Our Ref: LEC 2361

9 March 2017

Client: Fairview Ventures Limited
Development: Centric Close, Camden
Subject: Addendum to Energy and Sustainability Statements

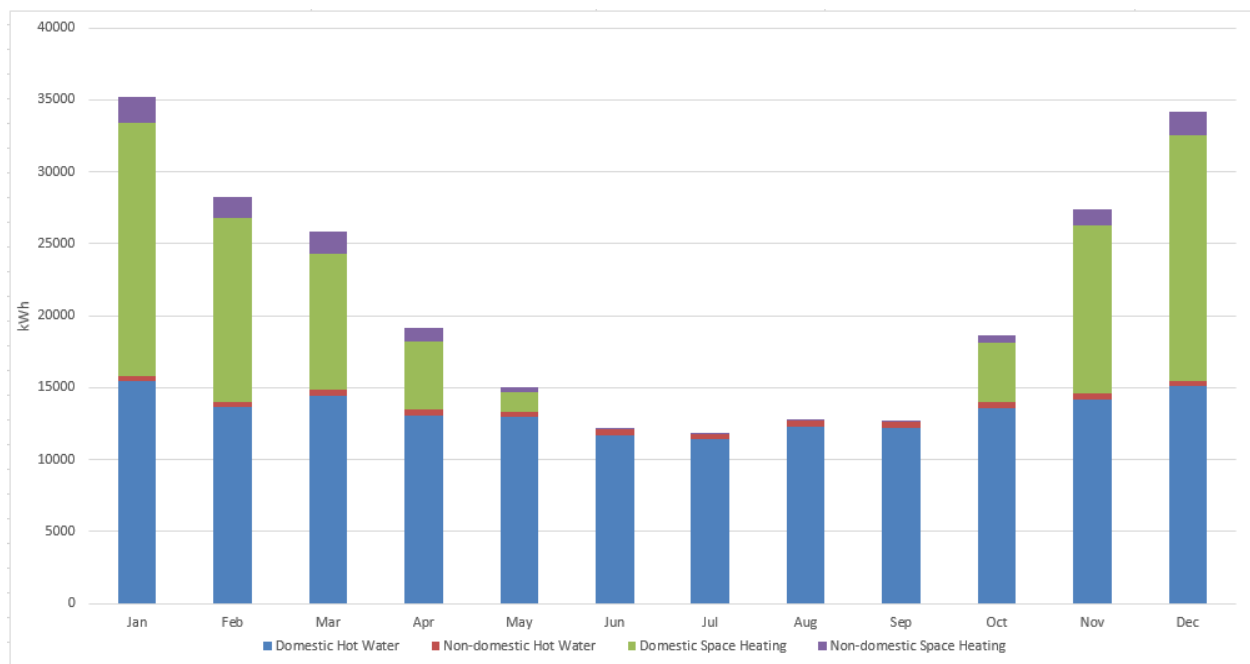
3. Statement/Comment - Suitability for on-site CHP: The applicant has not provided the following information to support the justification of CHP in the development – this information should be provided as an addendum to the report:

- *Details of the proportion heat demand provided by CHP, thermal stores, boilers and other technologies, illustrated as a heat profile showing:*

- Monthly demand profiles
- Typical monthly design day profiles
- *Details of other potential developments which could connect to the network and whether they have been included in the assessment. The developer should consider the potential for scheme extensions and new connections*

The annual hot water and space heating demand profiles for the entire development are illustrated in the figure below.

It is proposed that the CHP engine in combination with the thermal store will supply up to 75% of the total heat demand of the development. It is assumed that the CHP will supply all annual domestic water demand of the development and some of the space heating demand will also be supplied by the CHP.

The remaining space heating load will be met by energy efficient gas boilers, installed in parallel to the CHP unit. Indicative typical day profiles for January, April, July and October have also been developed to illustrate indicative operation of the CHP, thermal store and gas boilers.

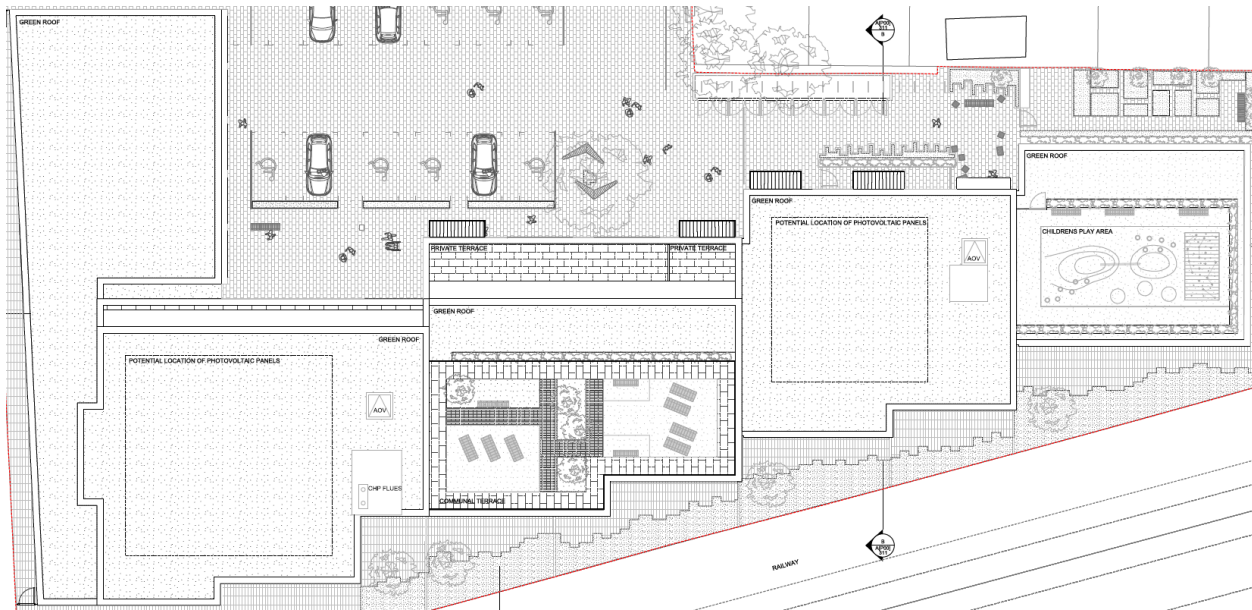
4. Statement/Comment - Solar PV: Plans show there may be a third roof space which could incorporate PVs – applicant should confirm if this is feasible.

The preliminary energy modelling indicates that 13.9kWp is sufficient to meet and exceed the 35% CO₂ reduction target onsite. It is proposed to locate the PV panels on the highest roof of the building which is

considered the most suitable for PV installation. The lower roof identified below is less suitable but could be used if the highest roof does not provide enough space to accommodate the PV requirement.

There are two other roof areas for consideration. However, these areas are unavailable as they have been allocated for communal terrace and children's play areas. The roof area above the commercial units is considered unsuitable as they will be largely overshadowed. It is therefore impracticable to meet a 20% renewables contribution from renewable energy given the London Plan target has already been met alongside the limited available roof space.

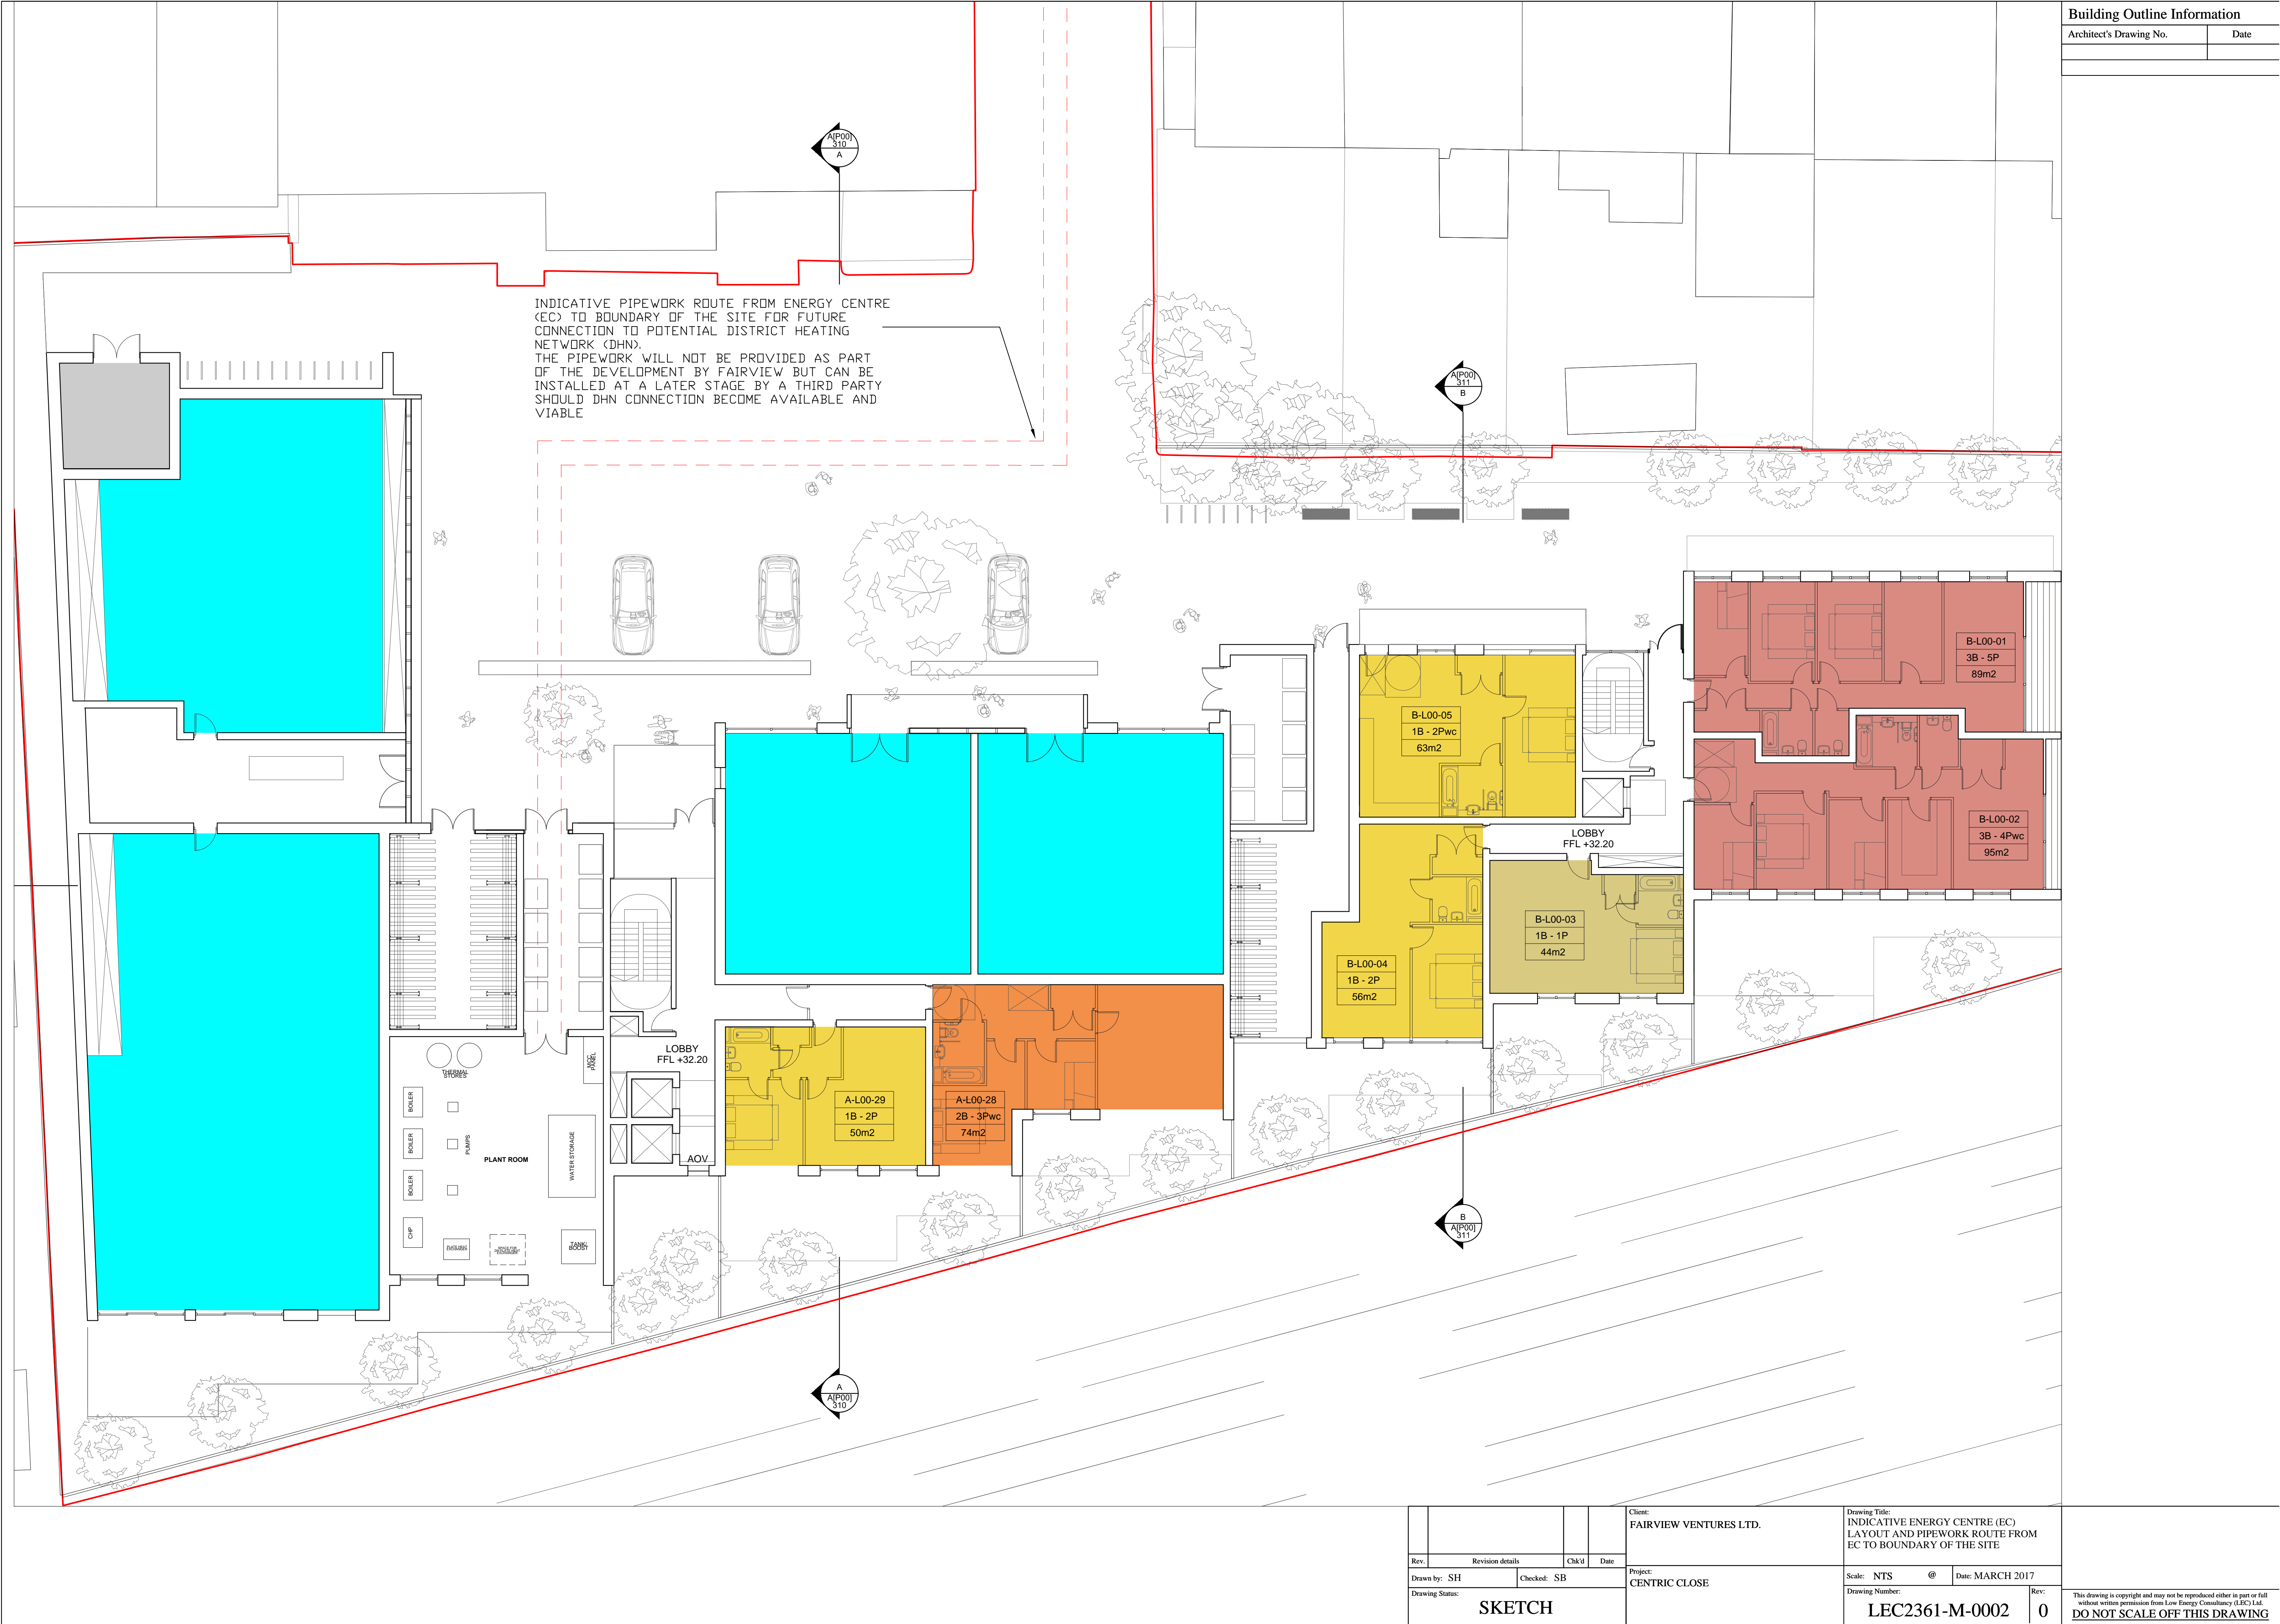
2. Statement/Comment - Opportunities to connect to a future network: The applicant should confirm the triggers for connecting to a network and also confirm the pipe routes and who will be responsible for installing the additional pipework should network connection be considered viable.

The plant room will be designed to accommodate and connect to potential near site district heating networks (DHN) should this become available and feasible in the future.

Based on available information and discussions with Camden Council, it is unlikely that a DHN will be developed in the area in the foreseeable future. Therefore, the installation of the pipework to the boundary of the site is not recommended as connection may never occur given the very limited opportunities. Installation of this pipework to the boundary will add unnecessary complexity and costs to the design.

Should connection become available and viable in the future, the pipework can easily be installed at a later stage, see proposed route across the car park to the boundary in Appendix A. The installation of the pipework should be carried out by the DHN supplier or by the energy management company of the on-site communal heating system if and when this option becomes available.
